AS BUILT
DEC 8, 1994

JEFFERSON COUNTY
LAW ENFORCEMENT CENTER
JEFFERSON, WISCONSIN

SECOND FLOOR PLAN
COURTHOUSE
1/8"=1'-0"

1-25-90
A8

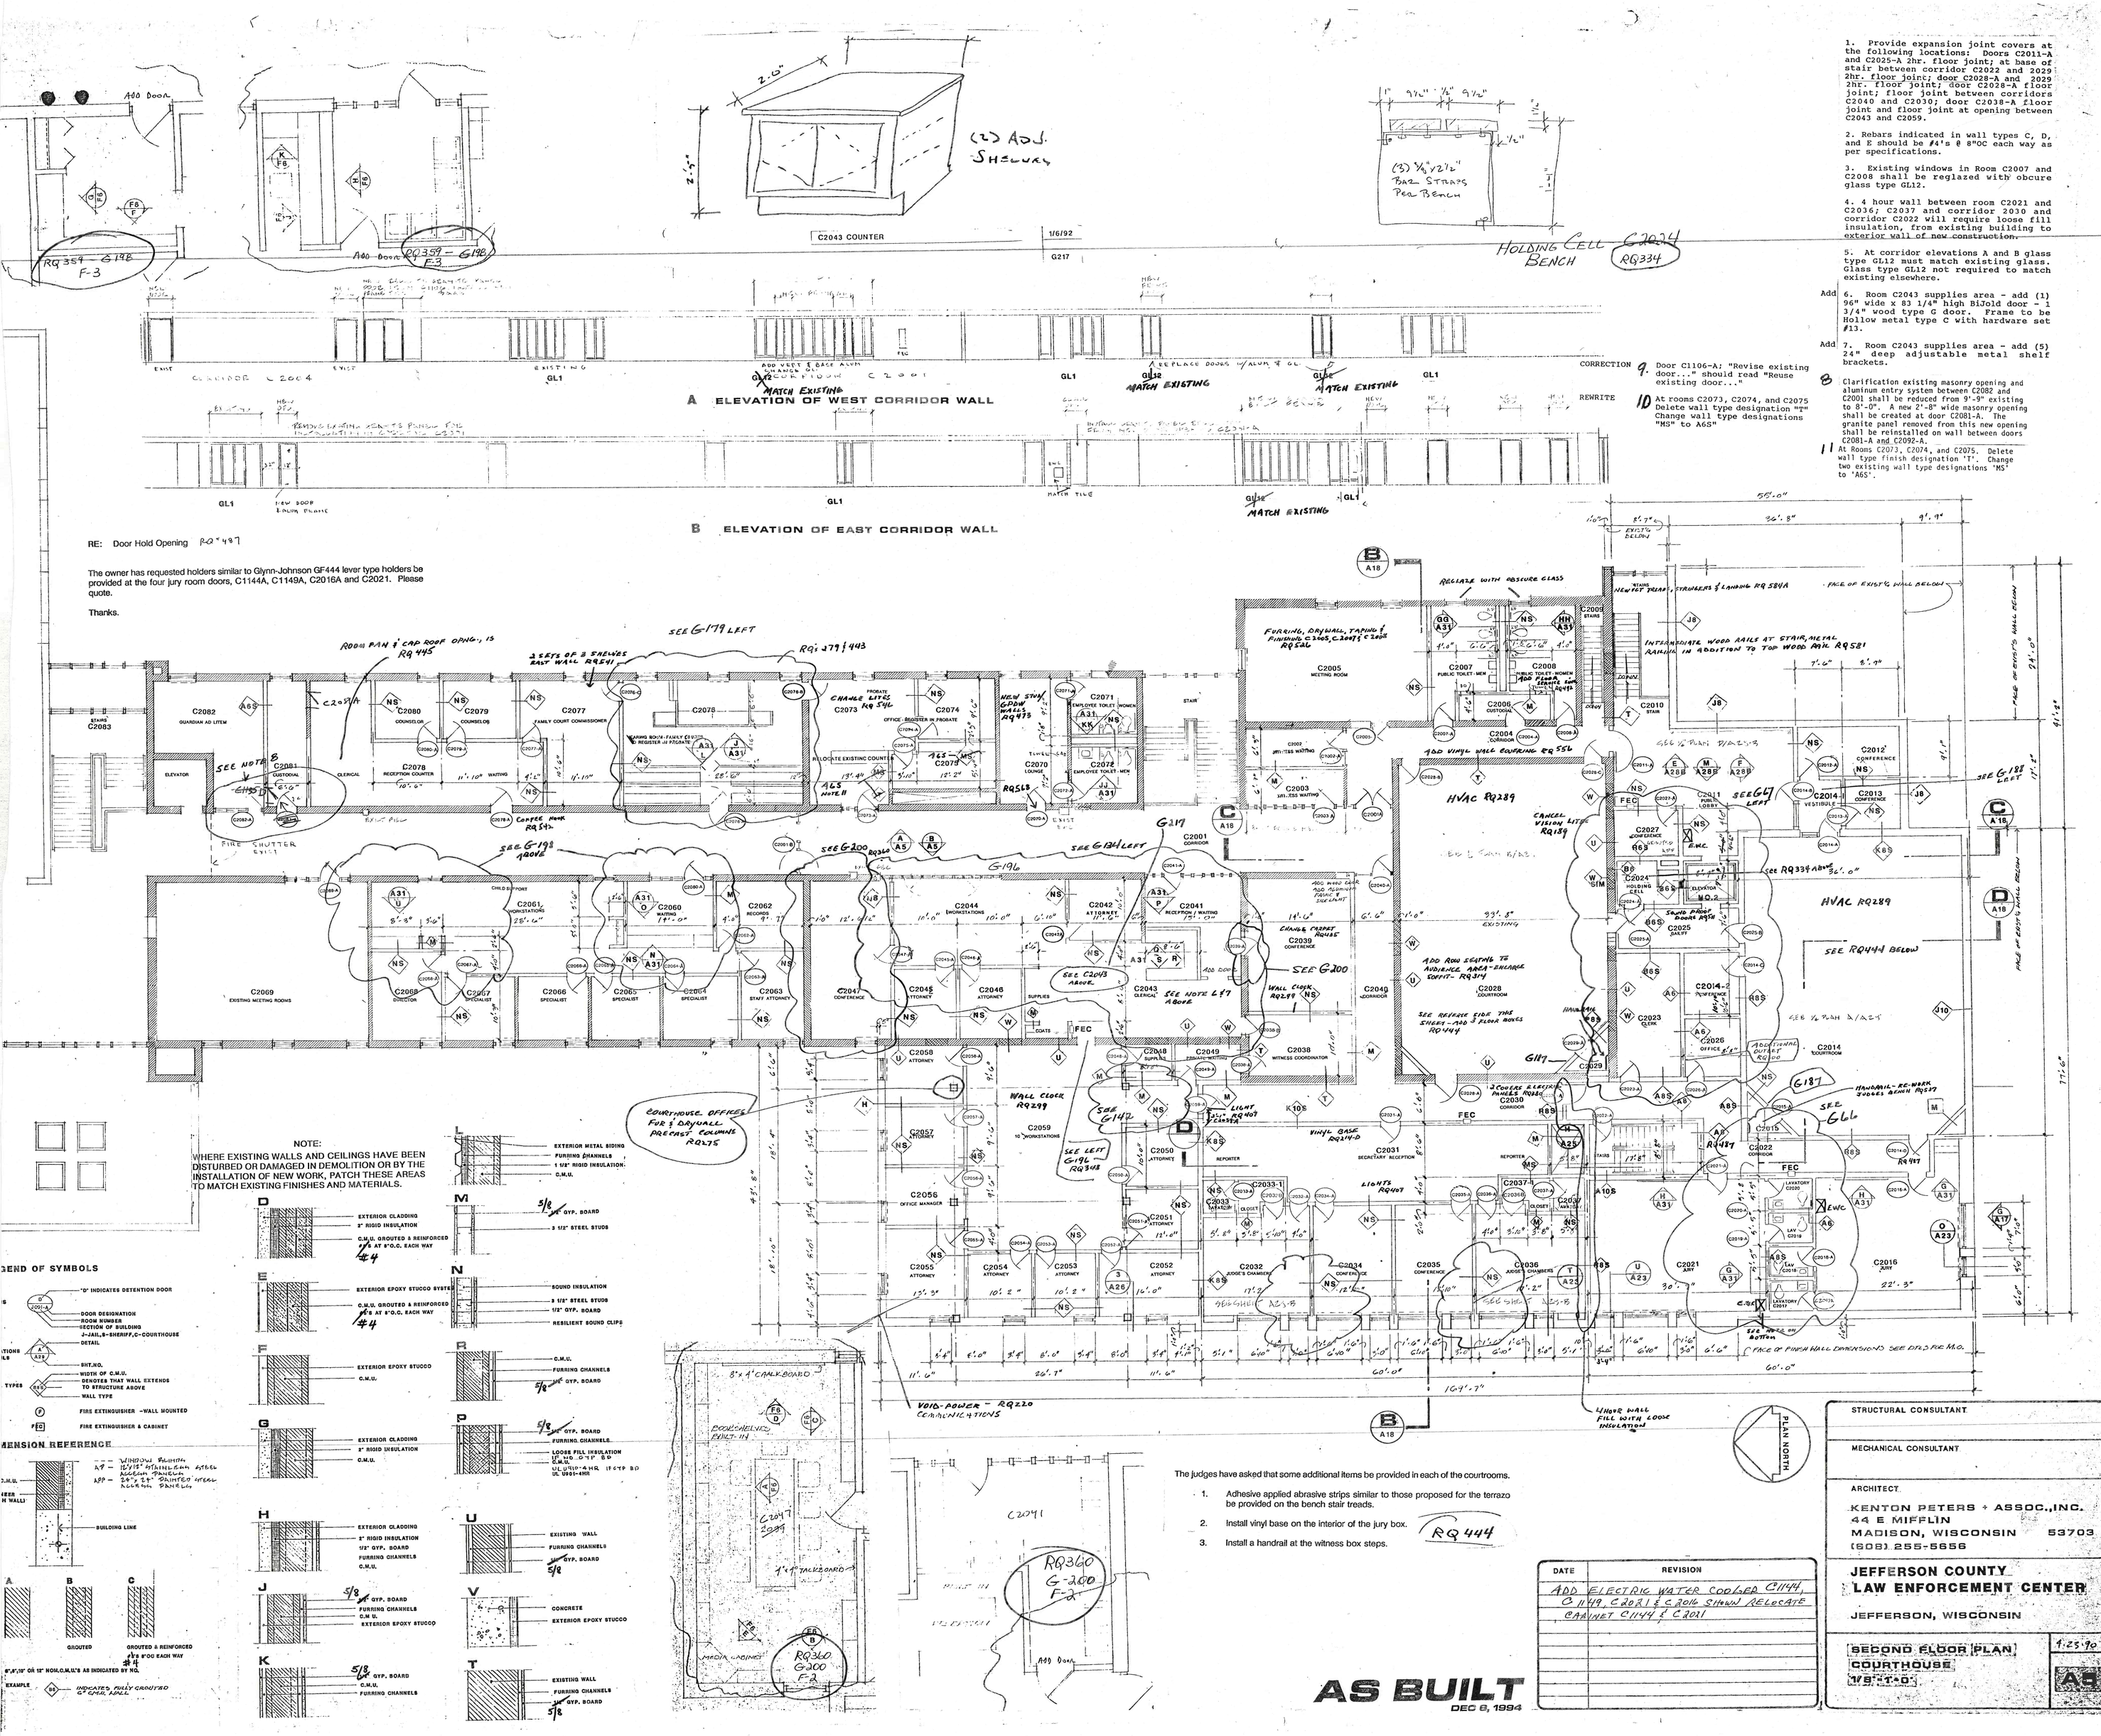
1. Provide expansion joint covers at the following locations: Doors C2011-A and C2025-A 2hr. floor joint; at base of stair between corridor C2022 and 2029 2hr. floor joint; door C2028-A and 2029 2hr. floor joint; door C2028-A floor joint; floor joint between corridors C2040 and C2030; door C2038-A floor joint and floor joint at opening between C2043 and C2059.

2. Rebars indicated in wall types C, D, and E should be #4's @ 8"OC each way as per specifications.

3. Existing windows in Room C2007 and C2008 shall be reglazed with obcure glass type GL12.

4. 4 hour wall between room C2021 and C2036; C2037 and corridor 2030 and corridor C2022 will require loose fill insulation, from existing building to exterior wall of new construction.

5. At corridor elevations A and B glass type GL12 must match existing glass. Glass type GL12 not required to match existing elsewhere.

Add 6. Room C2043 supplies area - add (1) 96" wide x 83 1/4" high BiJold door - 1 3/4" wood type G door. Frame to be Hollow metal type C with hardware set #13.

Add 7. Room C2043 supplies area - add (5) 24" deep adjustable metal shelf brackets.

8 Clarification existing masonry opening and aluminum entry system between C2082 and C2001 shall be reduced from 9'-9" existing to 8'-0". A new 2'-8" wide masonry opening shall be created at door C2081-A. The granite panel removed from this new opening shall be reinstalled on wall between doors C2081-A and C2092-A.

11 At Rooms C2073, C2074, and C2075. Delete wall type finish designation 'T'. Change two existing wall type designations 'MS' to 'A6S'.

CORRECTION 9. Door C1106-A; "Revise existing door..." should read "Reuse existing door..."

REWRITE 10 At rooms C2073, C2074, and C2075 Delete wall type designation "T" Change wall type designations "MS" to A6S"

The owner has requested holders similar to Glynn-Johnson GF444 lever type holders be provided at the four jury room doors, C1144A, C1149A, C2016A and C2021. Please quote.

1. Adhesive applied abrasive strips similar to those proposed for the terrazo be provided on the bench stair treads.
2. Install vinyl base on the interior of the jury box. RQ 444
3. Install a handrail at the witness box steps.

DATE	REVISION
	ADD ELECTRIC WATER COOLER C1144, C1149, C2021 & C2016 SHOWN RELOCATE CABINET C1144 & C2021
